City of Portland, Maine - Building or Use Permit Application
 389 Congress Street, 04101 Tel: (207) 874-8703, Fax: (207) 874-8716

Permit No: 01-0482	Issue Date: 17 2001	CBL: 353 E012
-----------------------	------------------------	------------------

BUILDING PERMIT REPORT

REASON FOR PERMIT: To Construct a 20'x20' deck

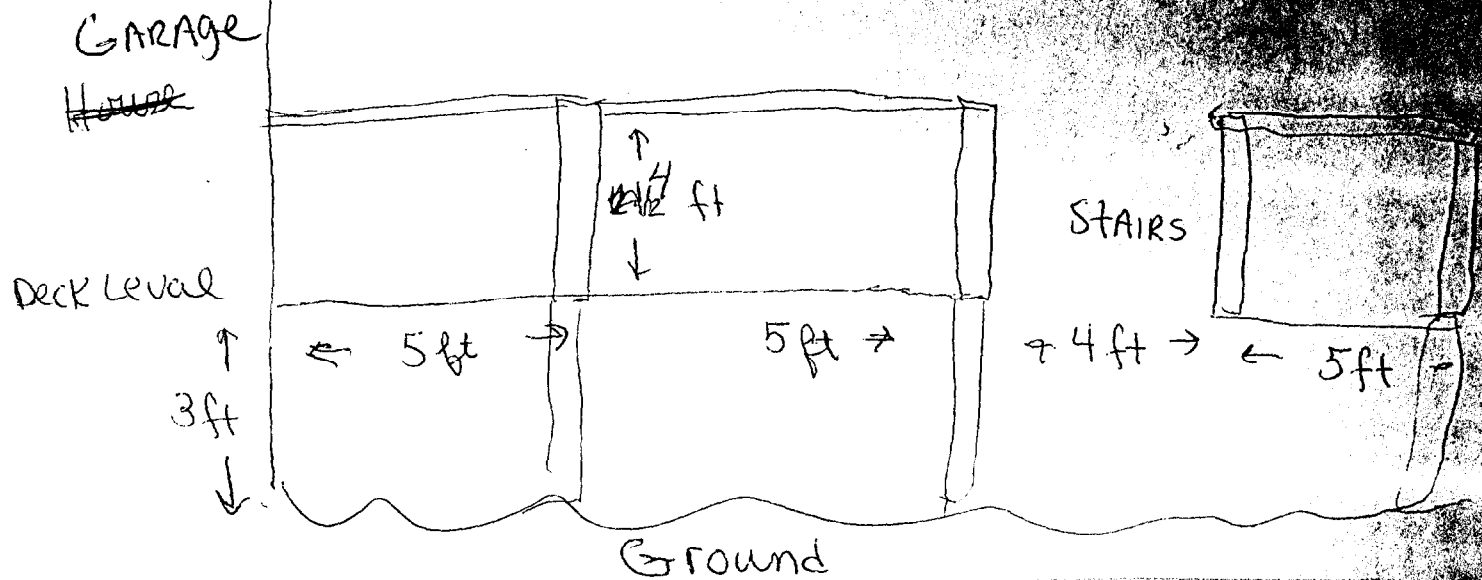
37. All signage shall be done in accordance with Section 3102.0 signs of the City's Building Code, (The BOCA National Building Code/1999).
- *38. MAX. SPAN OF 2x10" @ 16" OC CENTER IS 15'5" @ 12" OC, 17.3'

- 2" x 10" 16' MAX SPAN 15' 5"
- 2" x 10" 10' @ 12" 17.3' MAX SPAN
- Every joist has Joist hangers
- Every joist is 16" on center
- 7 2x10 (3' deep) 4' FLOOR DEPT
- Decking screws ✓
- 3" Galvanized nails ✓
- 4" x 4" for each post/rail ✓
- 7 Anchor bolts ✓
- 7 base post ✓
- 3 bags of cement each tube ✓
- 12' x 10' Decking ✓
- Tub sits on bed of crushed/small rocks ✓
